49 CFR Part 571

Federal Motor Vehicle Safety Standards; Electric-Powered Vehicles: Electrolyte Spillage and Electrical Shock Protection

ACTION: Final rule.

Figure 7b. S4, S5.3, S5.4.1.3, and S5.4.1.4 Jointed test finger IPXXB

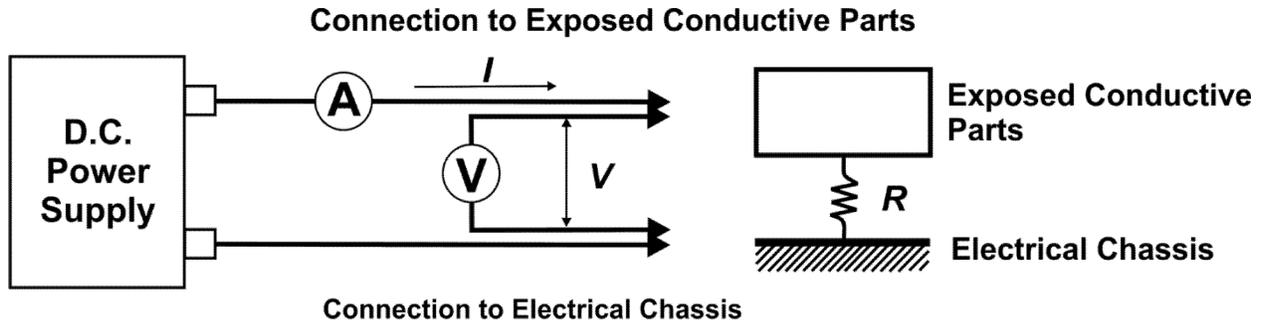
We make a minor correction to Figure 7b and clarify Figure 8.

The proposal provided specifications of the IPXXB probe in Figure 7b of the regulatory text. The Alliance and Global note errors in the specification for R2 and R4. The agency has corrected the errors in Figure 7b.
